Logan-Union-Champaign regional planning commission

Zoning & Subdivision Committee

Thursday, December 14, 2017

Staff Report – Darby Braeside

L:\Projects\Projects A-E\0326001\CAD\SHETS\03 - GRADING PLAN.dwg - Last printed: 11/22/2017 2:22 PM

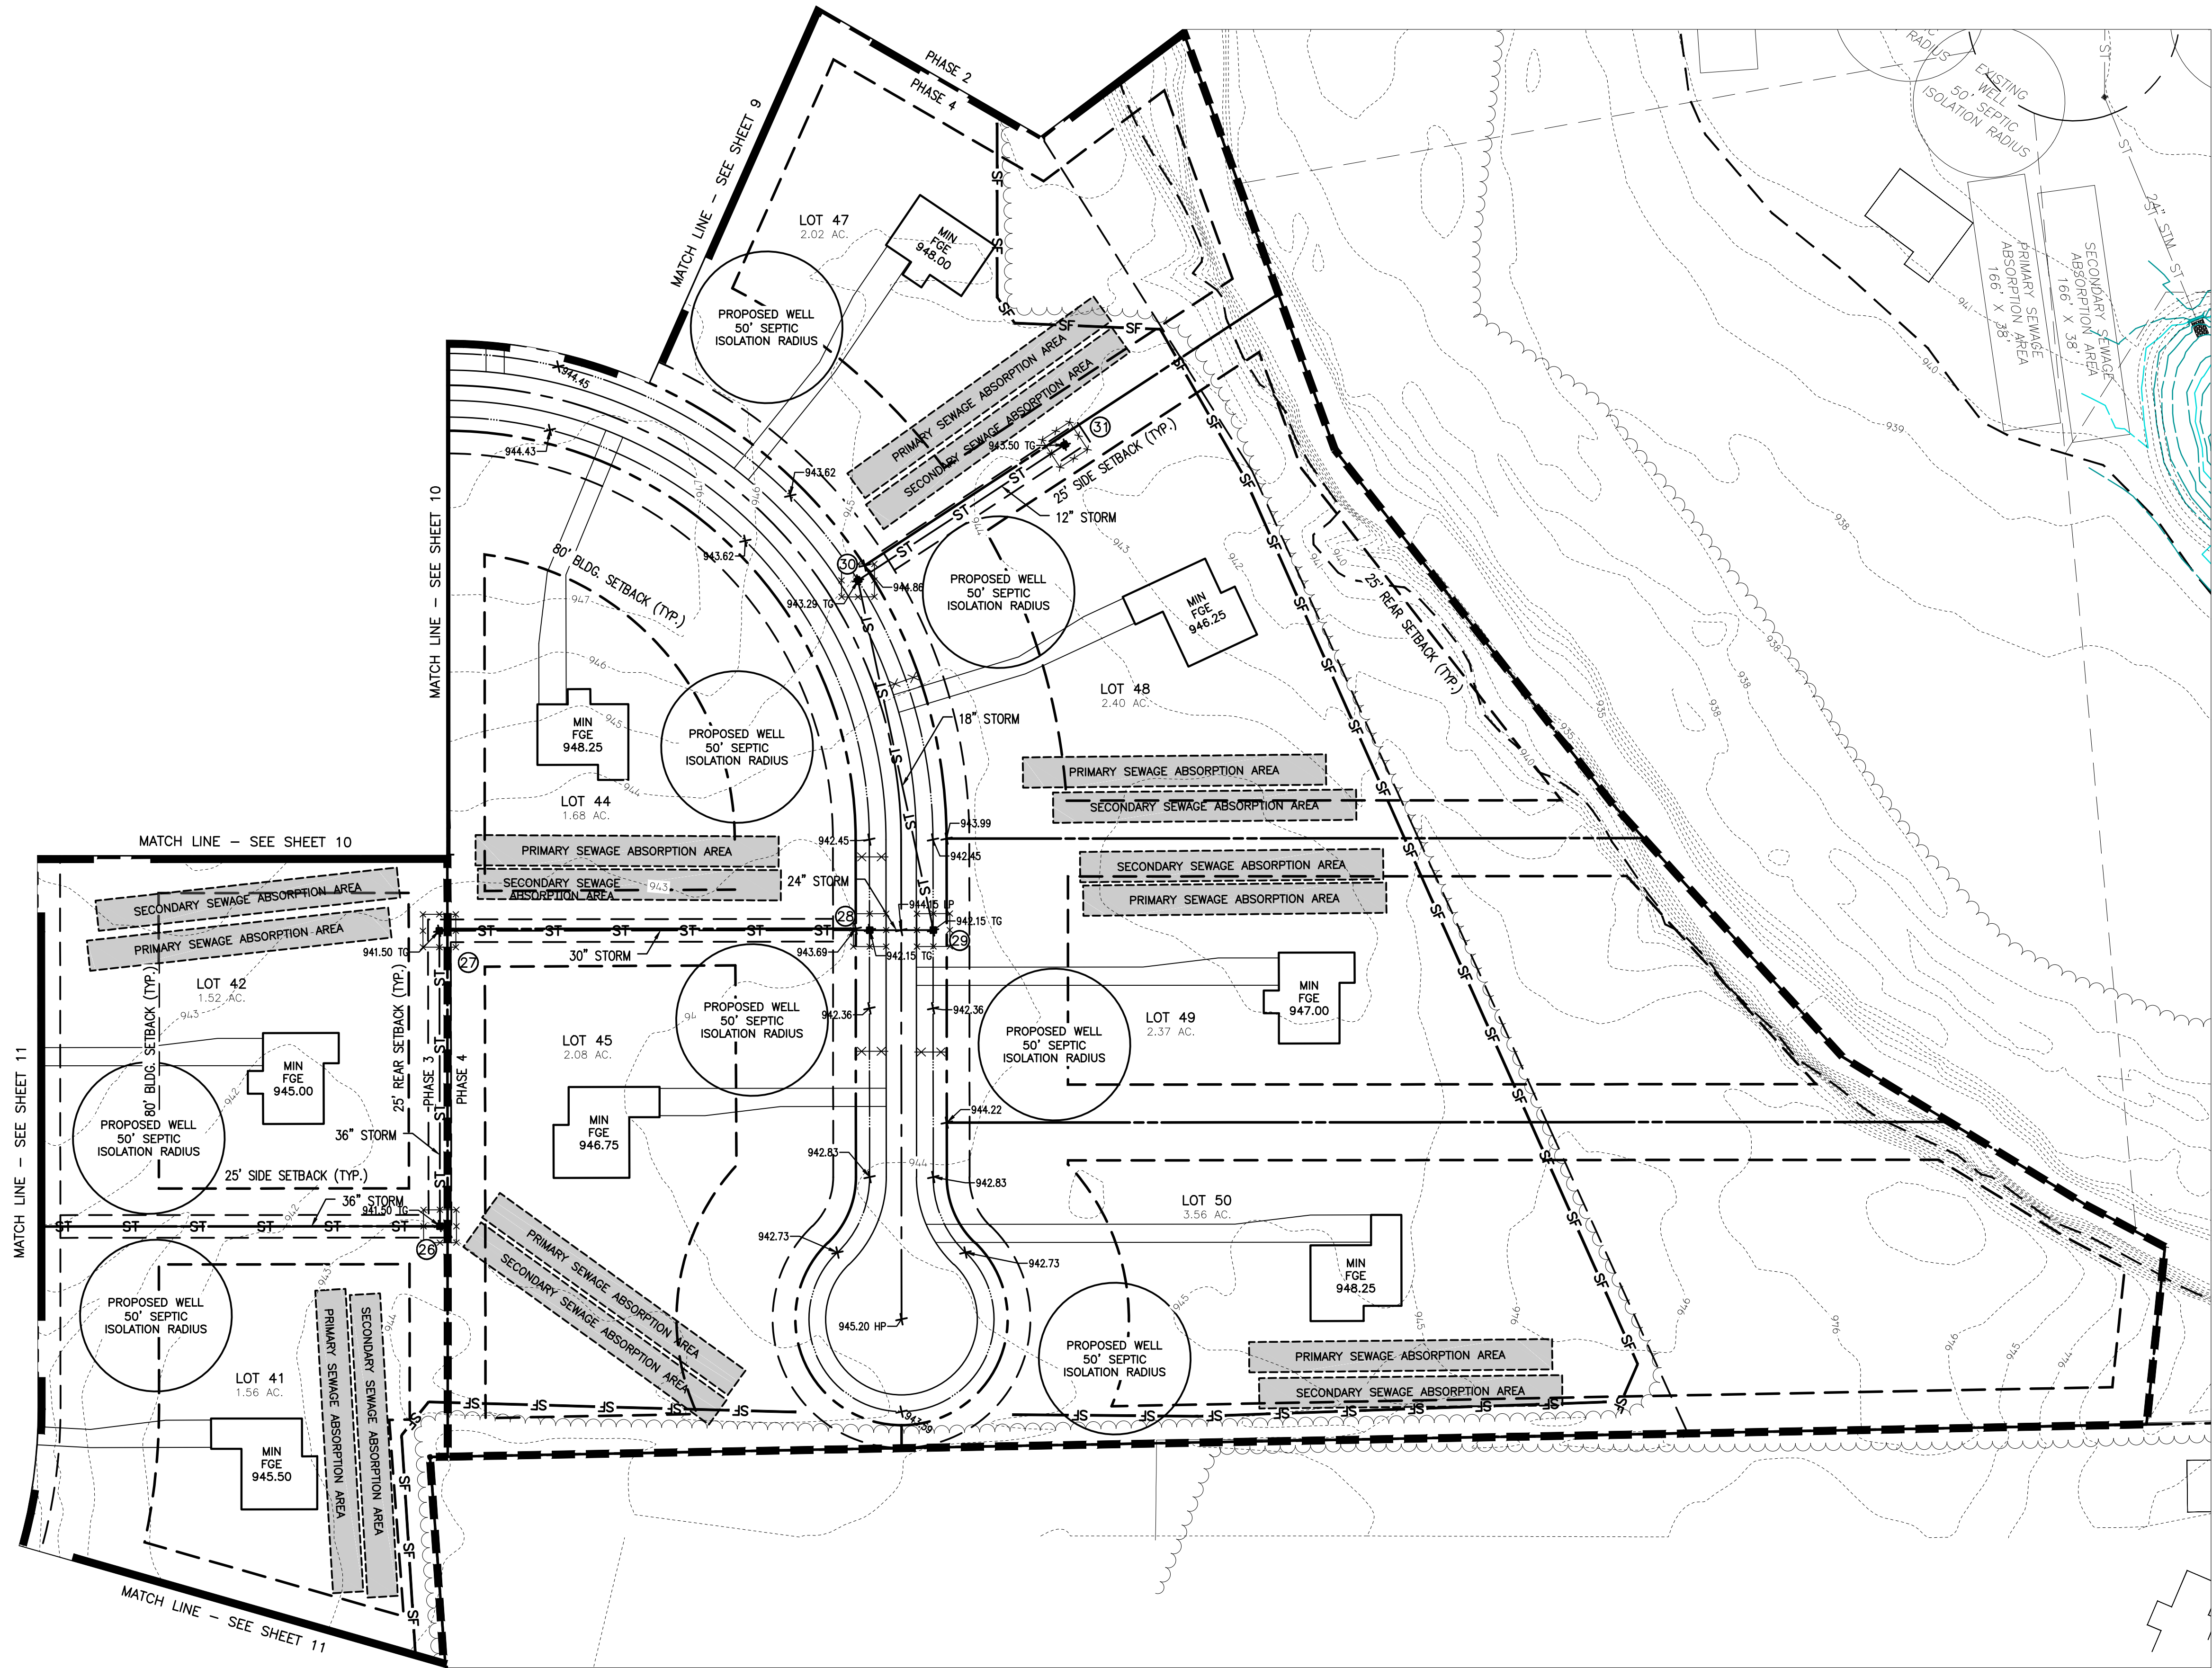
- 5) Sheet 9-12 of 19 – Site and Grading Profiles
 - a) With the amount of allocated space for storm, sewage and water wells UREC will need to work with developer engineering firm to establish offset easements between lots for primary or secondary facilities.

- b) Concerns with sewage absorption area with utility easements for Lots: 12, 16, 22, 43, 29, 34, 35, 36, 37, 39, 44 and 45.
- 6) Sheet 13-14 of 19 – Storm Sewer Profiles

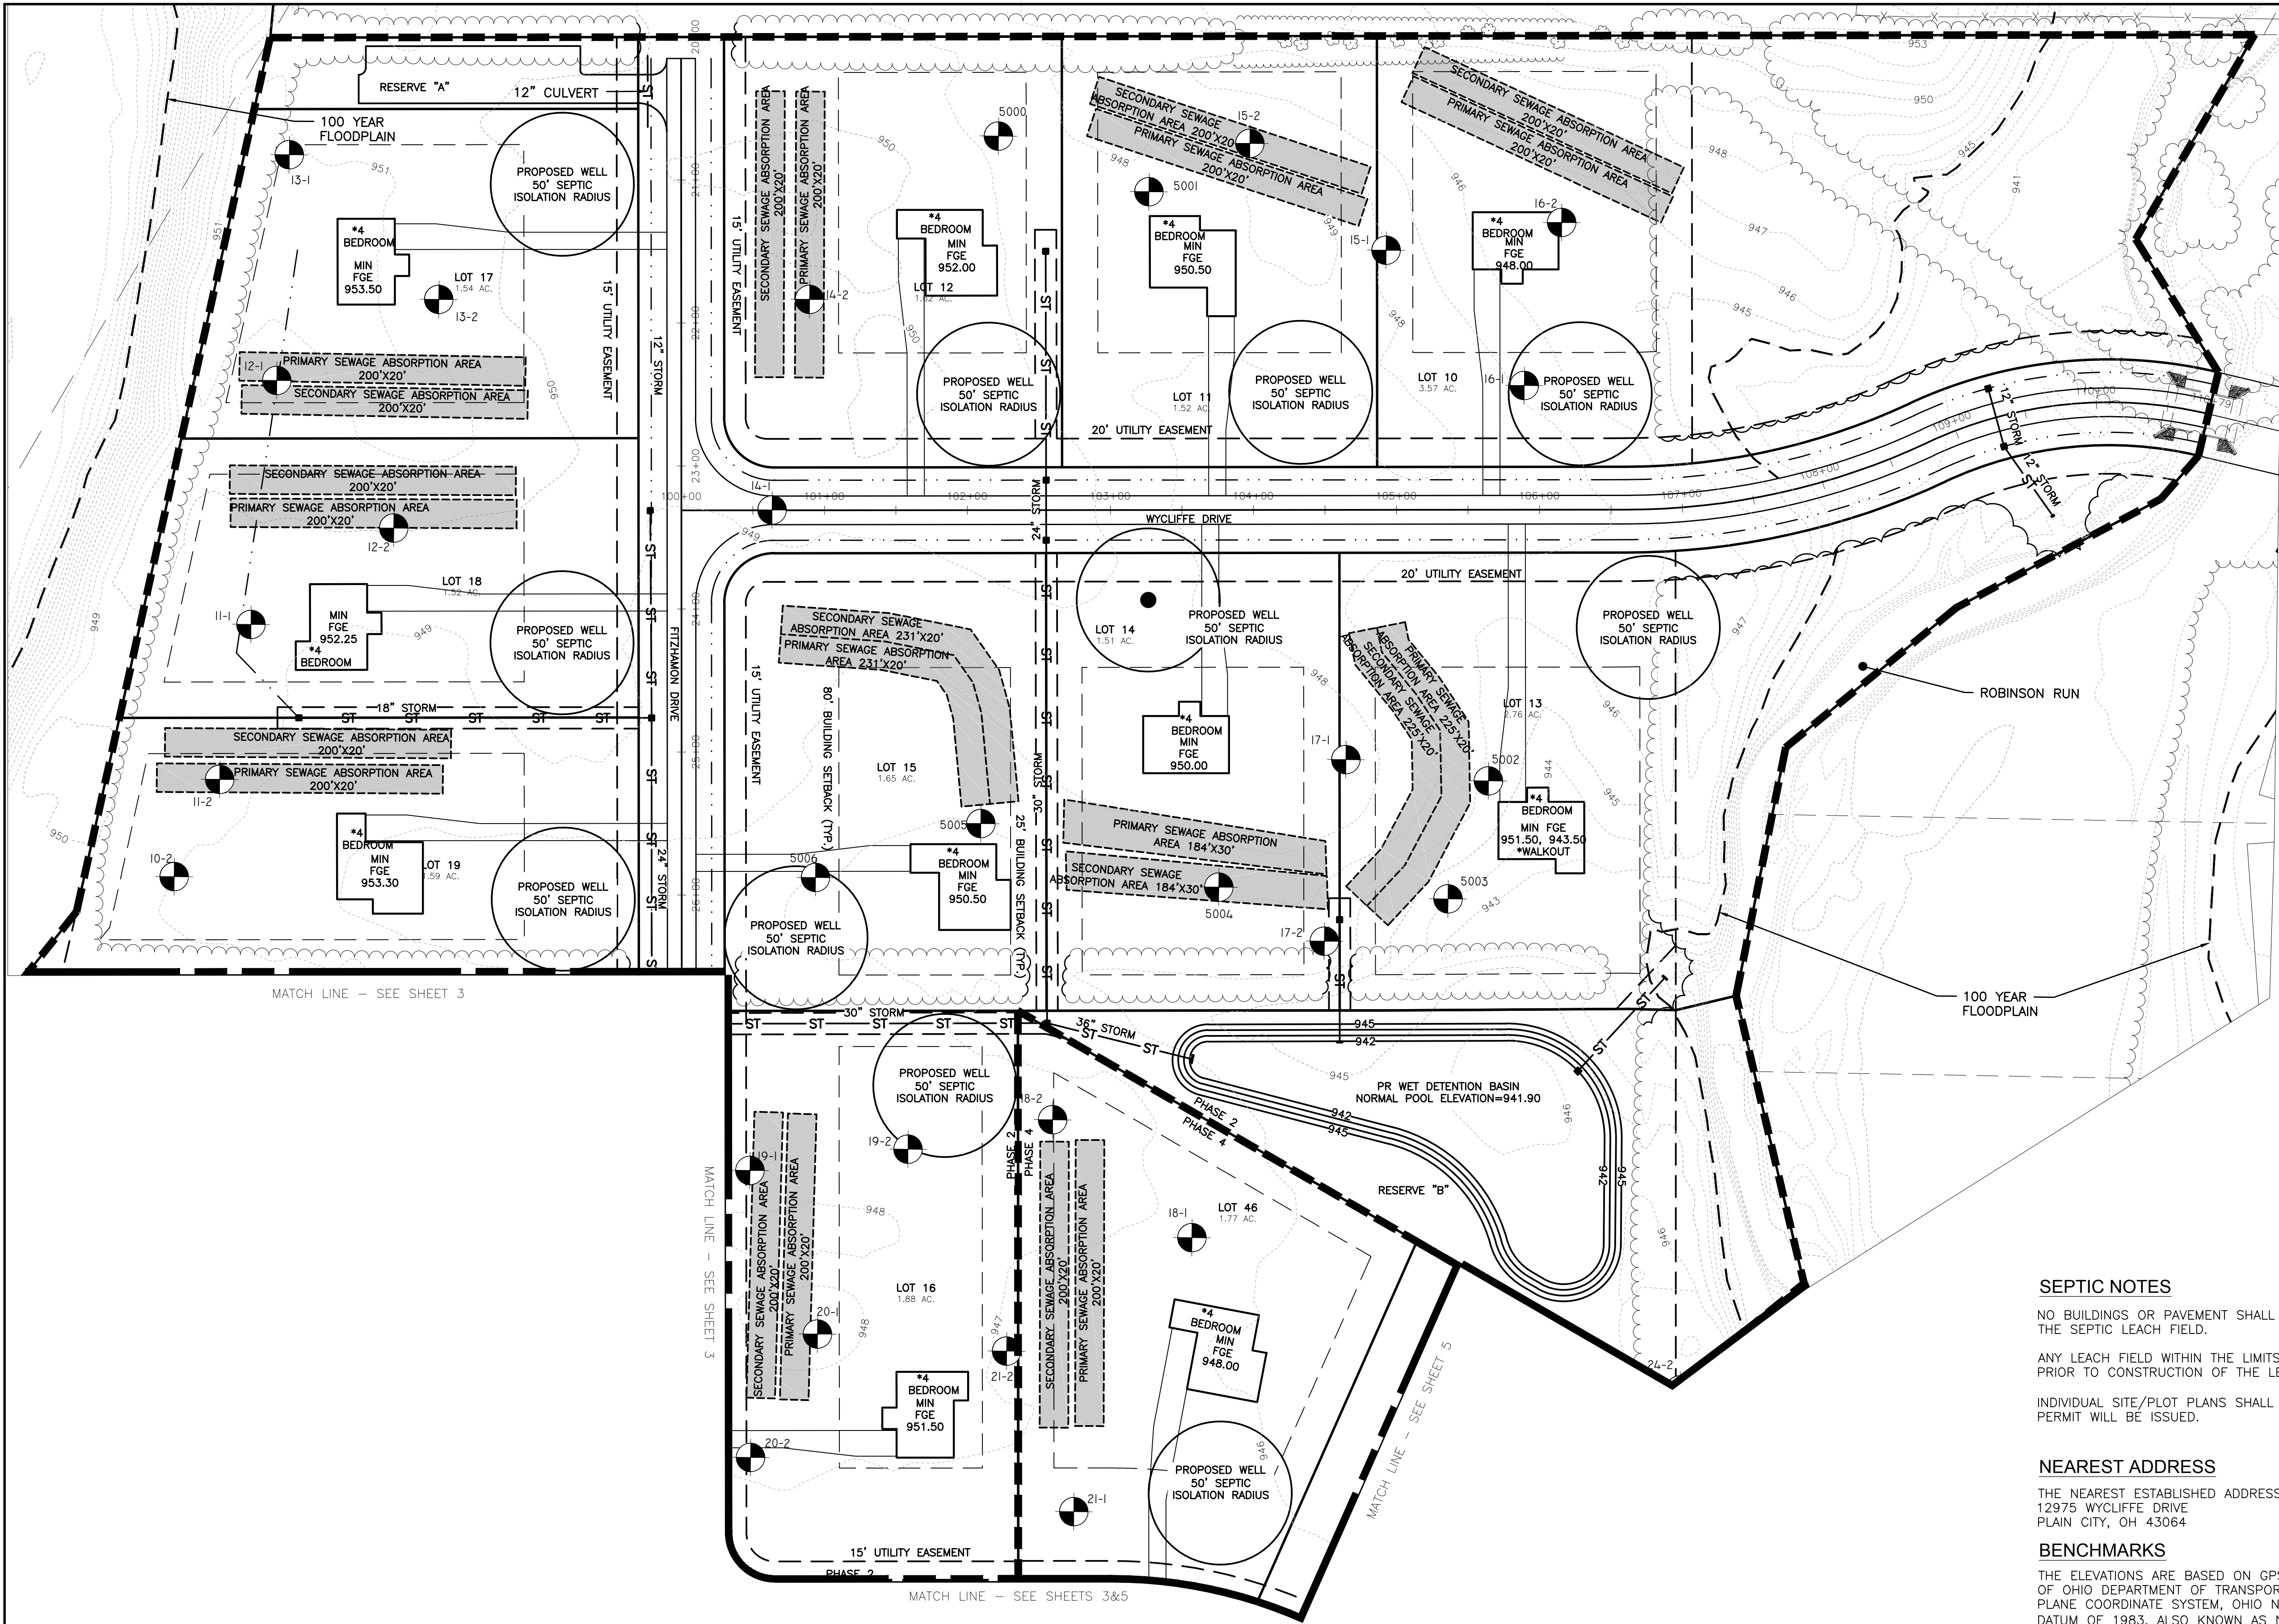
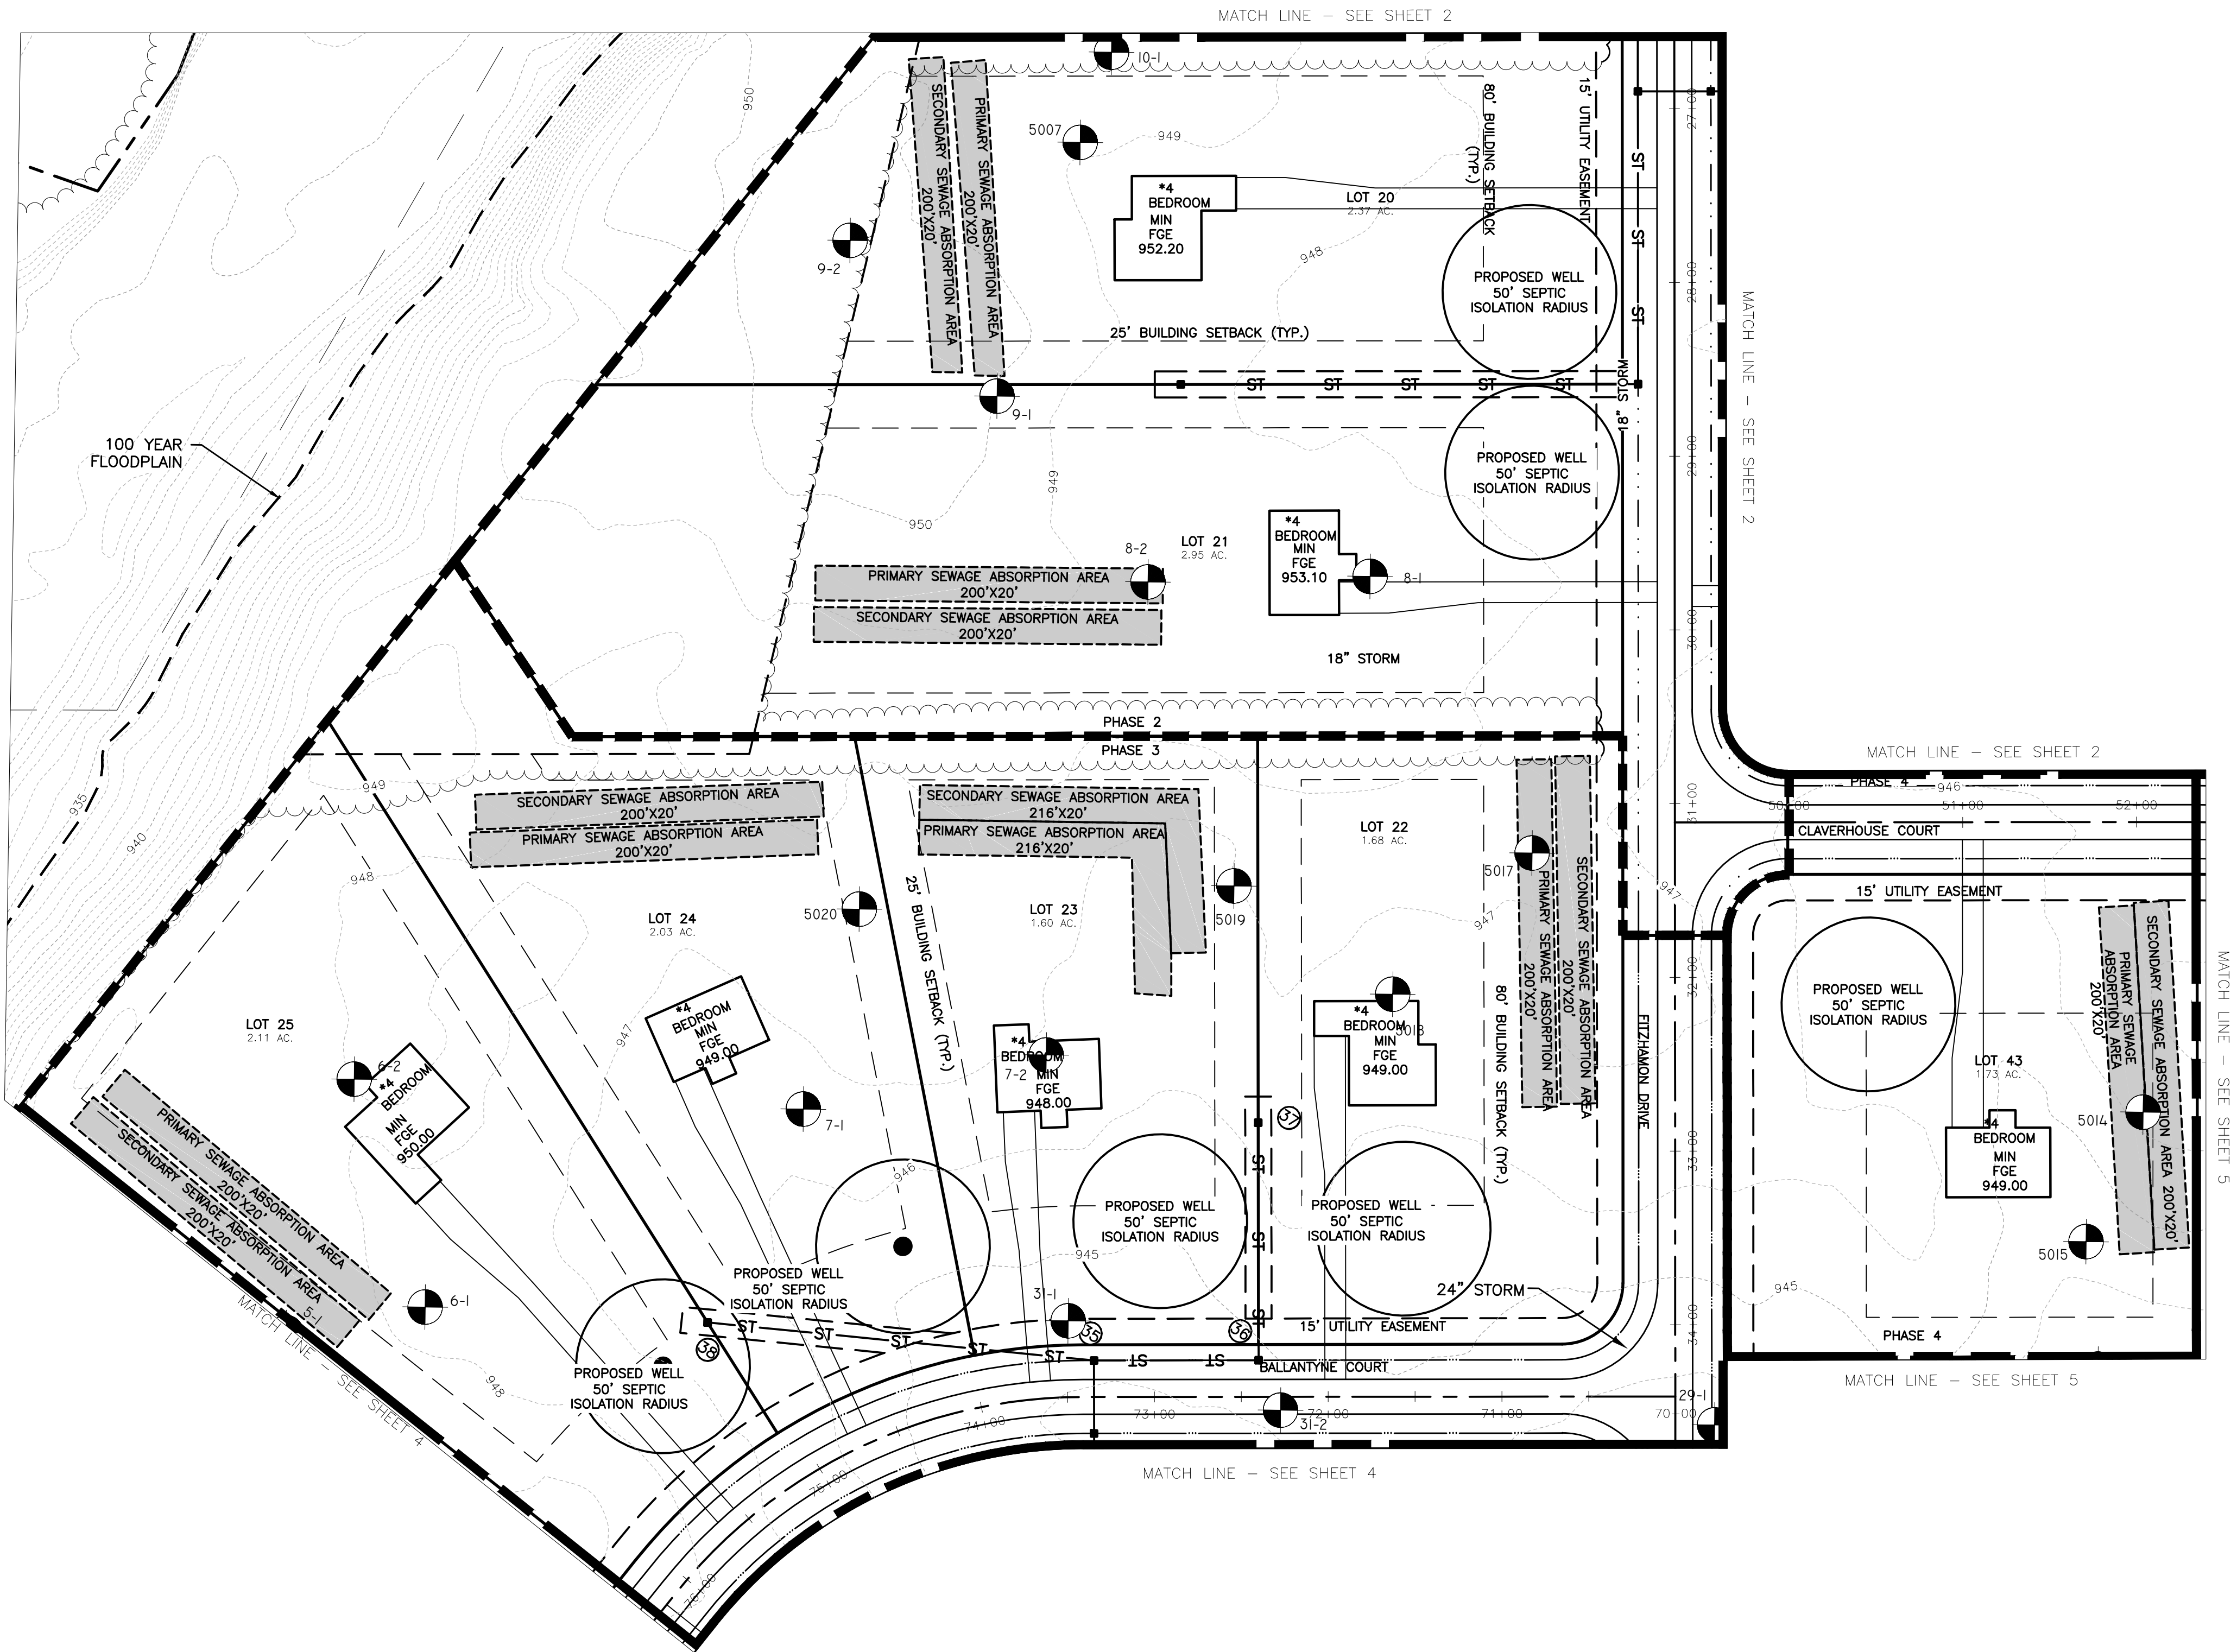
- a) Request other utility facility be noted.
- 7) Sheet 15 of 19 – SWPPP Details
 - a) No comments
- 8) Sheet 16-19 of 19 – Septic Plan
 - a) Same concerns as noted in item 5 above.
